Addendum Number 1Date: February 18, 2026Project: Klamath Transportation Building and Boat LaunchOwner: Yurok Tribe

This addendum provides changes and/or clarifications, to the Contract Documents. These modifications pertain to the sections referenced below and to all other referenced or applicable sections in the Contract Documents.

REVISED SPECIFICATIONS

REVISED CONSTRUCTION PLANS

**TRANSPORTATION BUILDING
LEVEL 1 - ELECTRICAL LAYOUT**

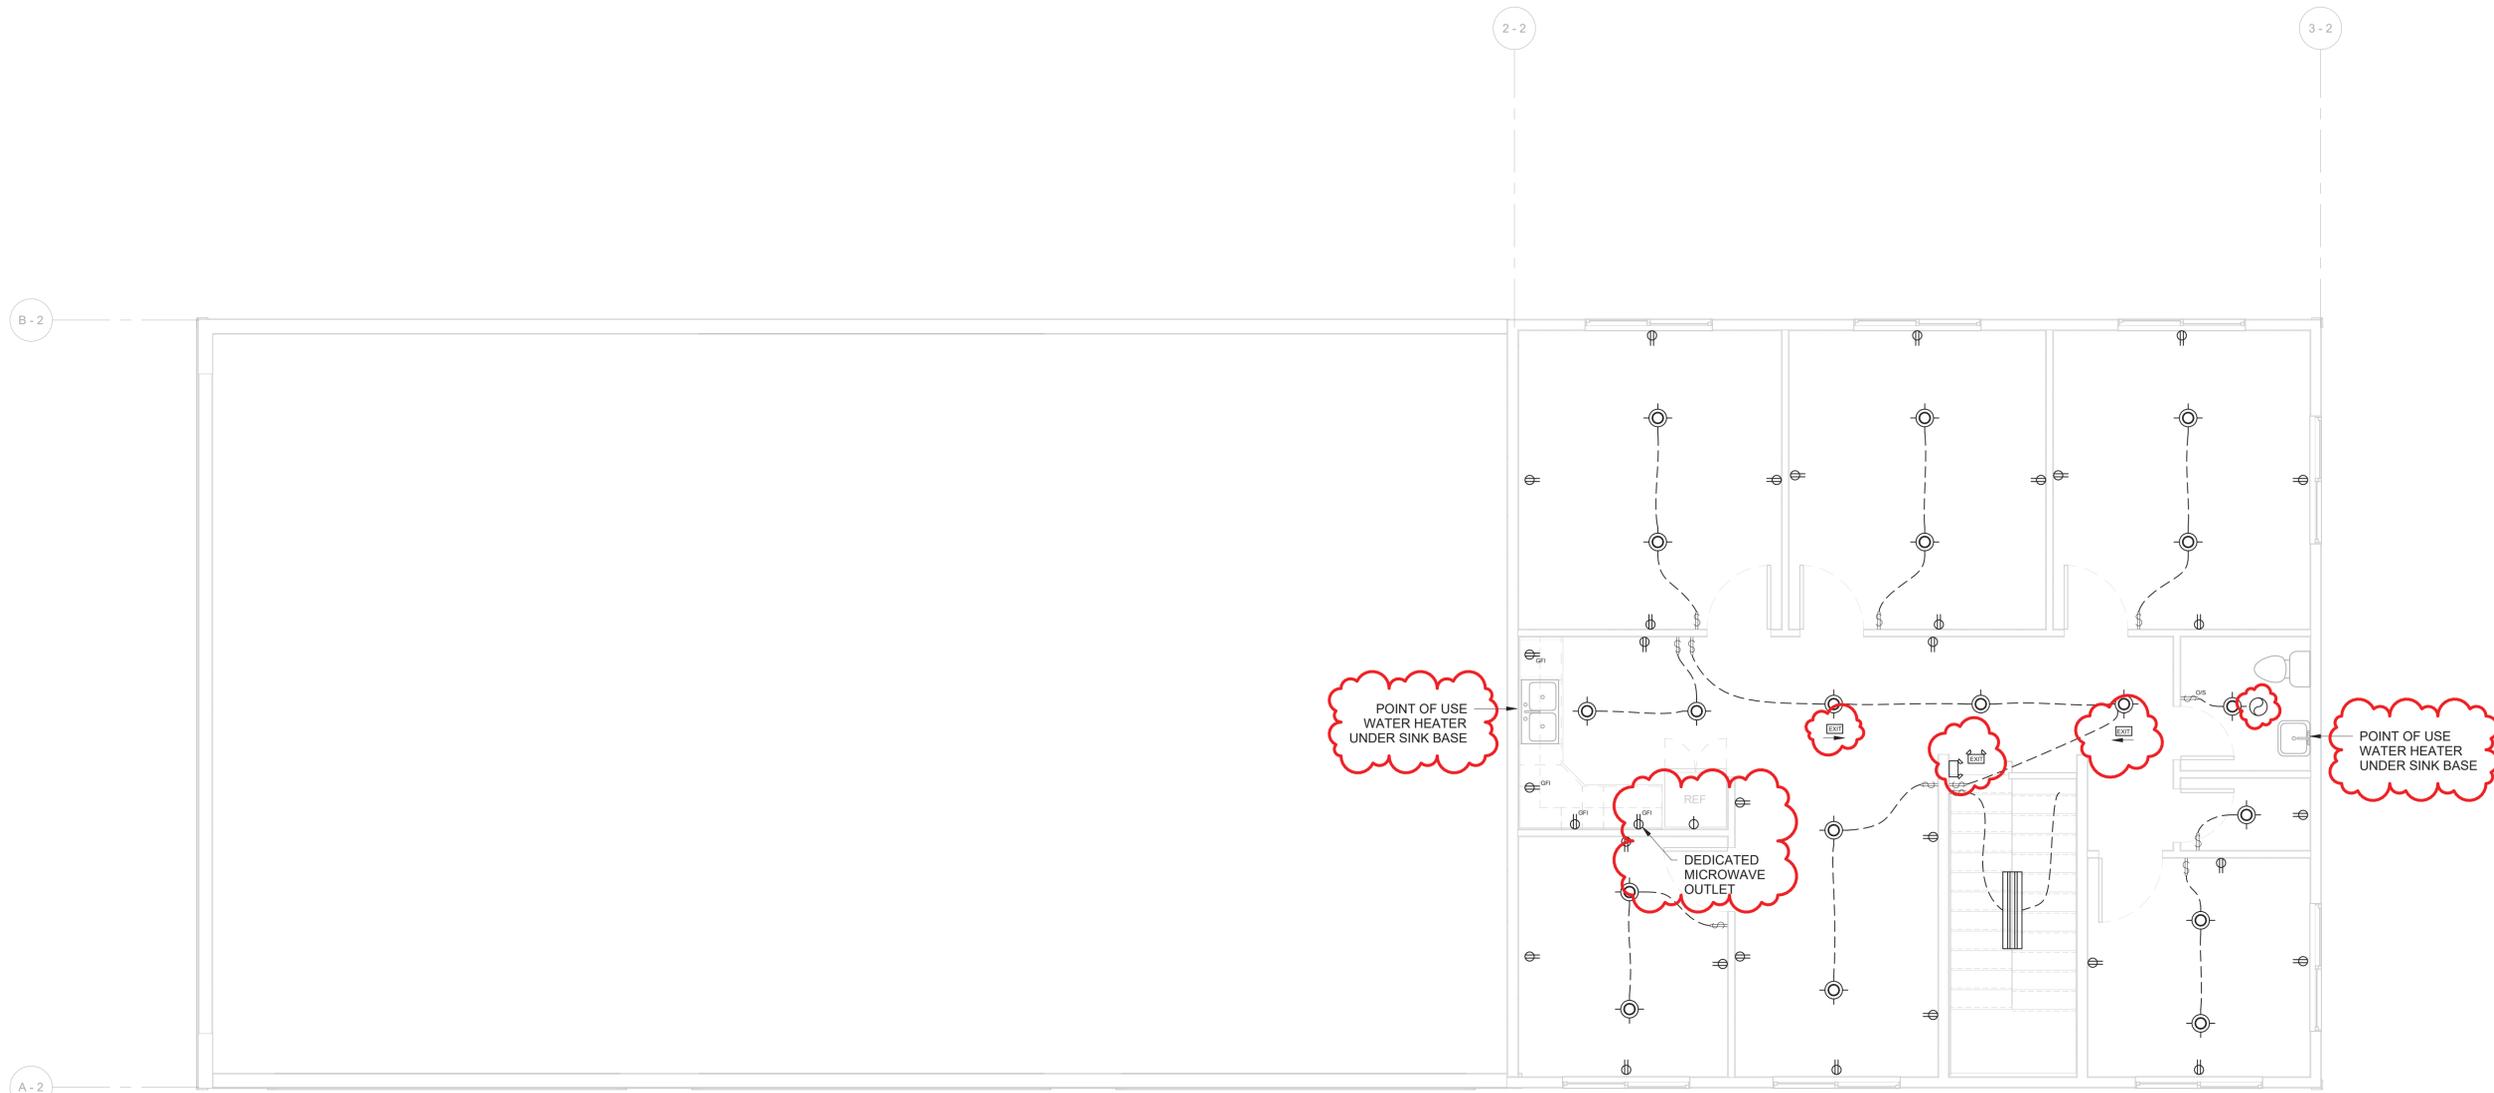
- Q) Fluorescent lighting is shown on lighting plans, Sheet E200 and E201. Fluorescent lighting is not really available for sale in California anymore. Is LED lighting acceptable?

A) See revised Sheet E200. Devices have been relocated to the adjacent wall.
- Q) Are there any required exit signs? Will they require battery backup illumination lights?
